Viking Warehouse Facility Stormwater Outfall Deficiencies Report

The City of Puyallup

February 27 2023

Figure 2.3: 2020 LiDAR topography with 2011 bank line in black showing bank erosion upstream of the outfall.

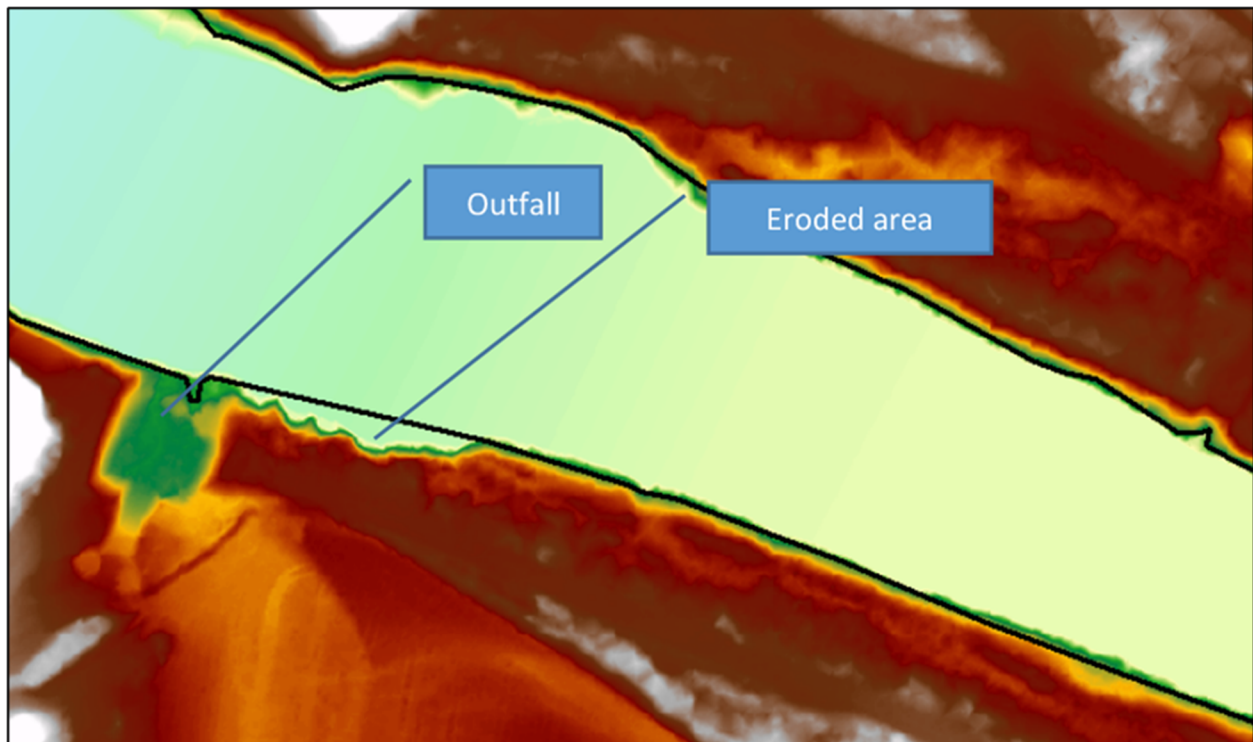
The bank immediately upstream of the outfall is eroding. Several trees have fallen in the past few years and a vertical soil bank is exposed. No riprap is visible in this bank, as compared to the bank on the downstream end of the outfall Figure 2.2. The erosion is clearly visible comparing 2011 and 2020 LiDAR (Figure 2.3).

Currently some erosion protection is being provided by fallen trees lining the bank, but these are deciduous and expected to decay or be washed away in the next few years. Further bank erosion here could flank the outfall and erode under the upstream edge of the Armorflex.

Figure 2.6: Velocity magnitude and flow path under pre-project (top) and post-project (bottom) conditions for the 10-year flood. Outfall outlined in black. Results from WEST HEC-RAS model.

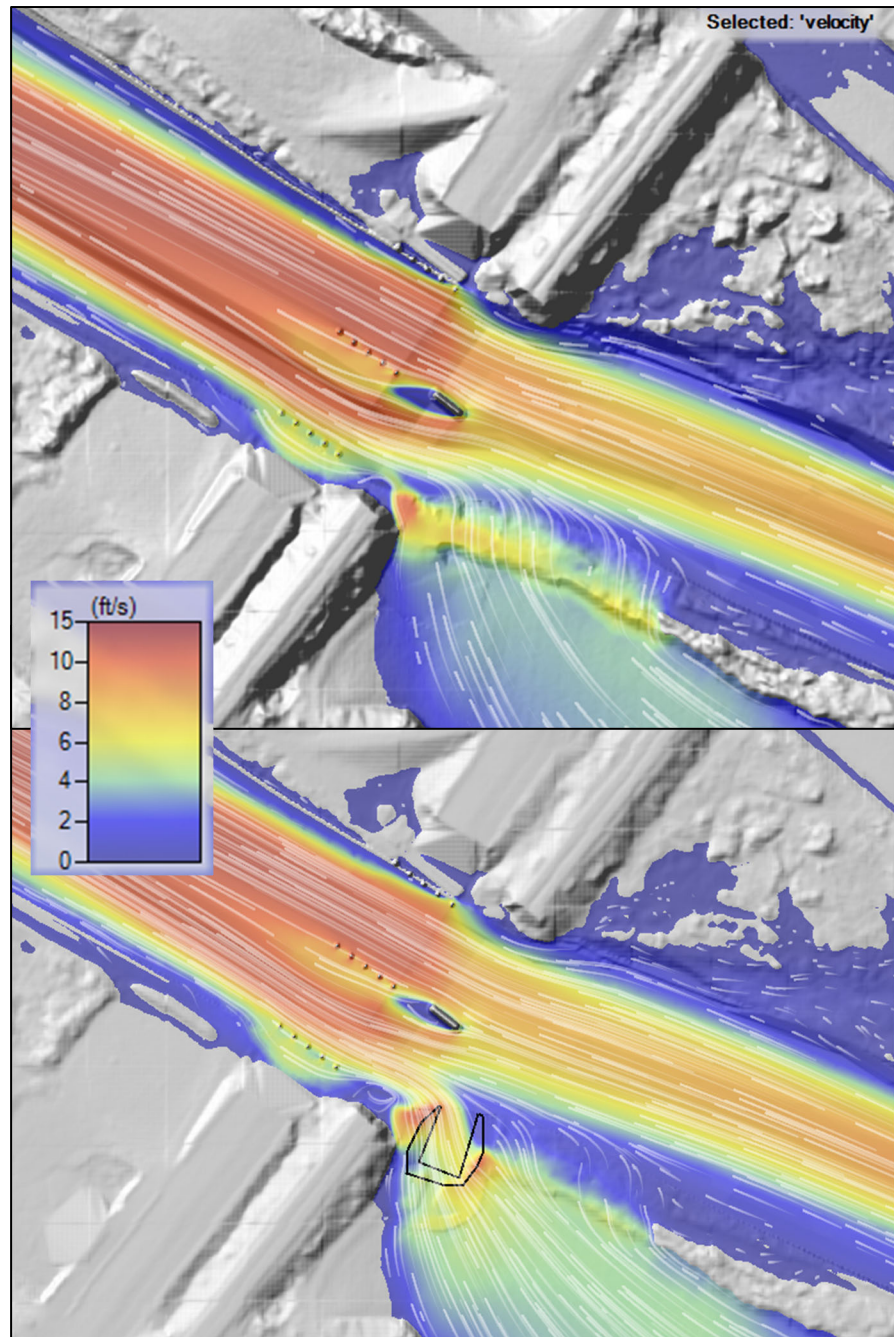
Removal of the levee and then further lowering the ground level for the outfall has created a point of concentration for these overbank flows returning to the river during floods. While this was always the case at this location, the outfall has increased flow velocities, concentration of flow, and shear stresses. Figure 2.6 shows results from the WEST Consultant hydraulic model of the site used to evaluate scour risk. Velocities are increased in the area of the outfall as the return flows accelerate into the main channel. Velocity hotspots exceed 10 ft/second on both the up and downstream edges of the outfall. While the Armorflex layer is likely capable of withstanding this, the high velocities also occur outside the limits of the Armorflex. The upstream high velocity area is of more concern due to the lack of erosion protection measures outside of the Armorflex. Downstream of the outfall and transitioning into the bridge abutment, riprap is visible, appears to be in generally good shape, and the modeling indicates it has likely been repeatedly exposed to these high velocities in prior floods. Furthermore, the site has been exposed to a 10-year and 25-year flood since construction with no apparent overbank damage around the perimeter of the outfall, so this risk appears to be less of a concern than the other types of ongoing erosion at the site.

The constructed outfall is expected to increase the risk of local scour at the base of the outfall embankment for each of the modeled flood scenarios if the existing countermeasures in place at the outfall are not sufficient (Table 4). The greatest anticipated change between pre- and post-project conditions will occur at the 10-year event, where results show the scour depth will increase by about 38%. The increase in local scour for the post-project condition is caused by an increase in unit discharge flowing over the outfall, which nearly doubles from the pre-project condition in which the levee is unnotched.

The scour depths the WEST report refers to are calculated for the bed of the main channel. The WEST report concluded that there was no risk to the railroad bridge from the outfall, but this analysis did not evaluate the risk of bank erosion at the outfall

progressing down into the bridge embankment. We see this as the highest potential risk to the bridge from the outfall. We note that while these high velocity river return flows may be infrequent, the depths, velocities and shear stresses they generate are significantly larger than those created by stormwater discharge from the pipe. It is possible some of the failure on the riverbank is due to both these return flows and mainstem flows as discussed earlier.

Figure 3.3: Adapted plan view of As-Built changes from the originally approved outfall structure design.

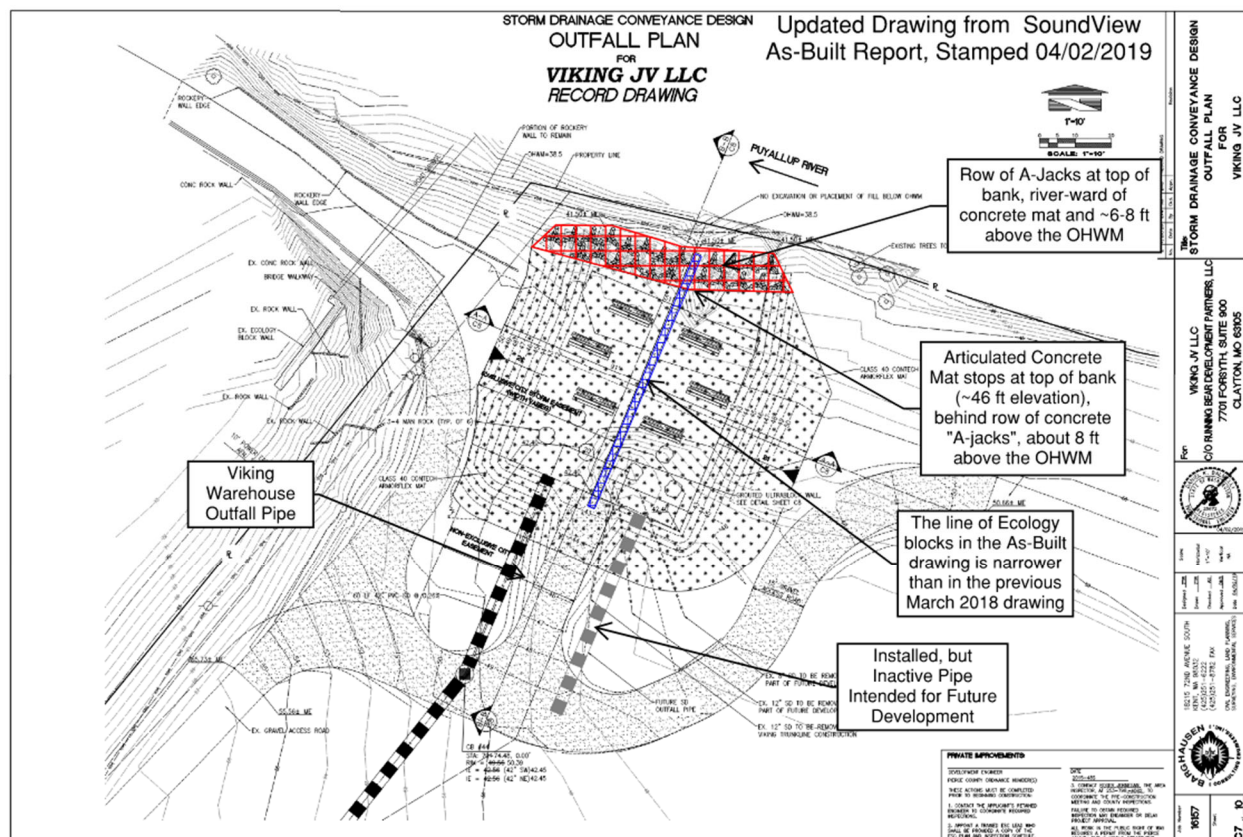
The As-Built drawings (Figure 3.3, Figure 3.4, and Figure 3.5) showed the following changes to the outfall structure relative to the previously approved (3/27/2018) structure design drawings:

- In 2020, the Contech articulated mat is shown as stopping near the top of bank, about 10-15 ft landward from the OHWM (Figure 3.3 and Figure 3.5) at about 46 ft elevation, rather than the 2018 design (Figure 3.1, Figure 3.2, and Figure 3.4) which showed the articulated mat extending over the top of slope and down the bank to 2 ft below the 38.5 ft elevation OHWM.
 - No engineering documentation was provided to explain why this change was made. From a permitting standpoint, this revision would eliminate direct hard-armor impacts to the river (a Water of the US [WOTUS]), and also avoided federal review of the outfall structure and associated new impacts to the Puyallup River.

- Deadman anchors on each side of the outfall structure in the 2018 design drawings (Figure 3.2 and Figure 3.4) are not shown in the As-Built drawings (Figure 3.3 and Figure 3.5), but individual log anchors are shown.
- Coir logs with willow stakes originally shown on the upslope side of the horizontal logs (Figure 3.4) were moved to the downslope side of the logs (Figure 3.5).
 - Note, despite the side view drawing (Figure 3.5) indicating fewer logs were installed in 2020, the plan view drawing shows that a total of six logs were installed, the same as the March 2018 design.

Figure 3.5: Side view of As-Built (2020) changes from the originally approved outfall structure design.

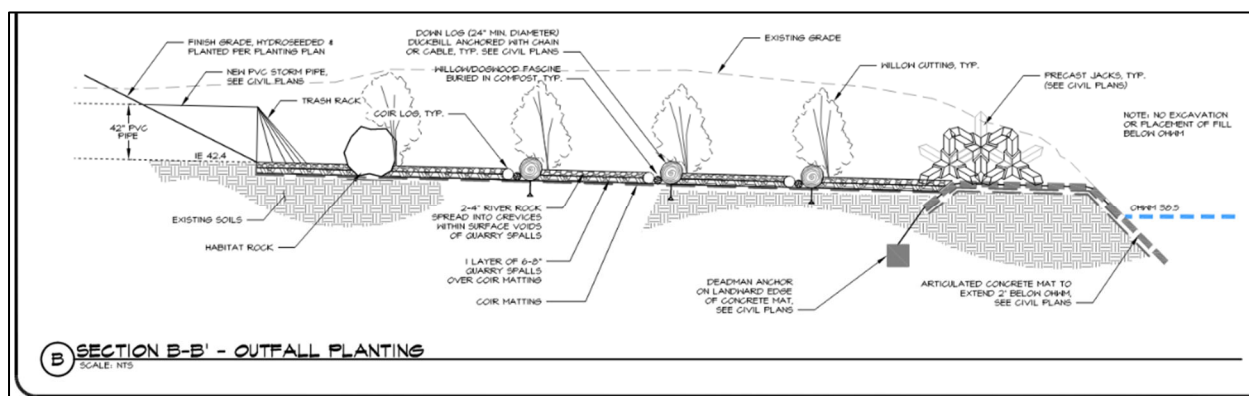
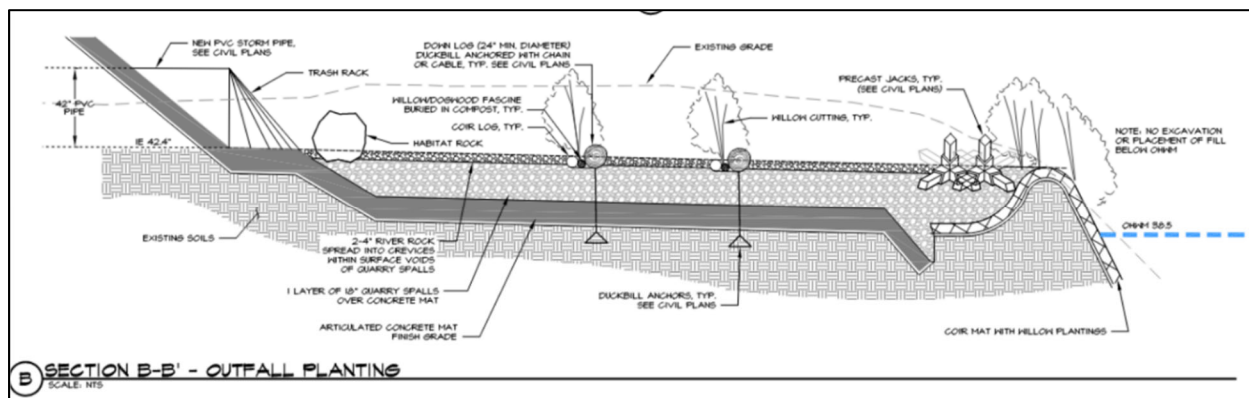
- The A-Jacks which previously were situated above the Contech mat at top of the bank (Figure 3.4) were instead installed on top of a coir fiber mat laid over a constructed soil berm at the top of the riverbank (Figure 3.5). The coir mat starts about 10-15 ft landward from the top of the bank and extends riverward to below the OHWM. The top of bank berm was subsequently planted with willow wands (see Figure 3.5).
